Product Modifications and Additions

AO and SDCF Handle Improvements:

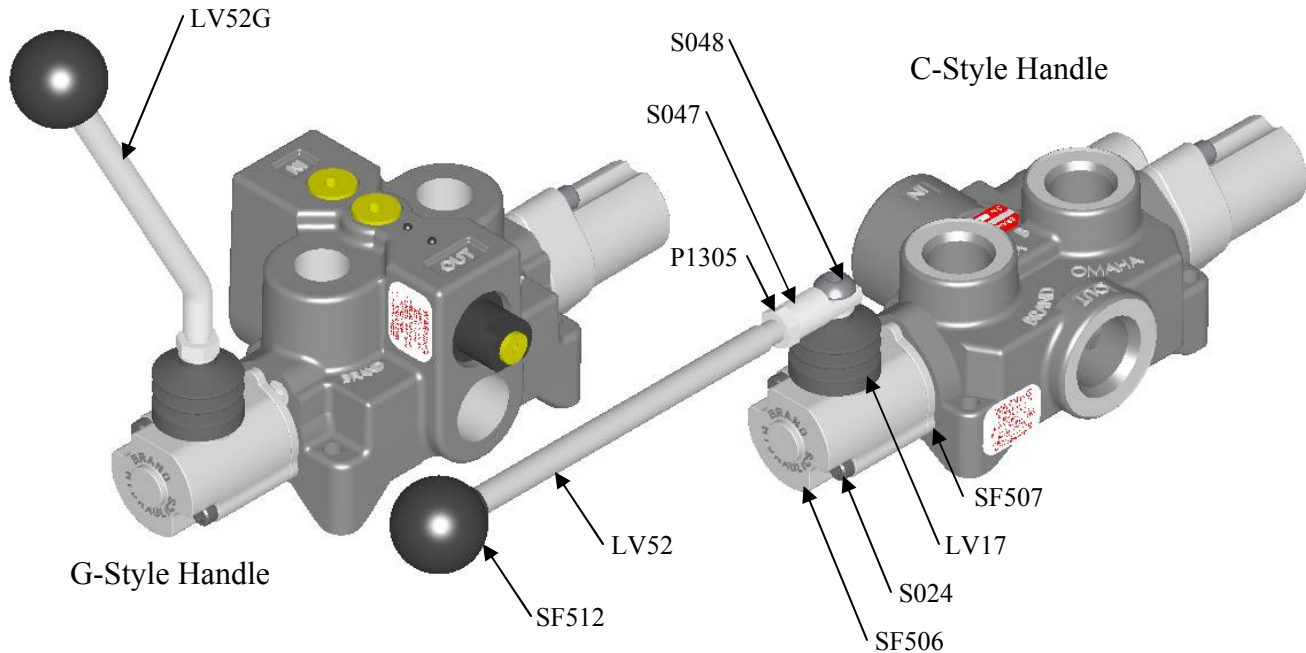
Brand Hydraulics has listened to its customers again, and increased the value of the AO and SDCF by designing an enclosed handle. We've added a vertical "G" and horizontal "C" enclosed handle. These new handle styles are meant to replace the current "L" style handle. We would like to have everyone switched over to the enclosed handle by February 2009. Option "G" and "C" style handles will be available beginning in the middle of July 2008. The list adder for the "G" style is \$3.00 and the list adder for the "C" style is \$5.00.

The enclosed handle functions the same as the "L" style handle as far as feel, travel, and shifting angle. It provides a cleaner look, keeps out contaminants and protects the spool. Please contact us with any questions on the new design.
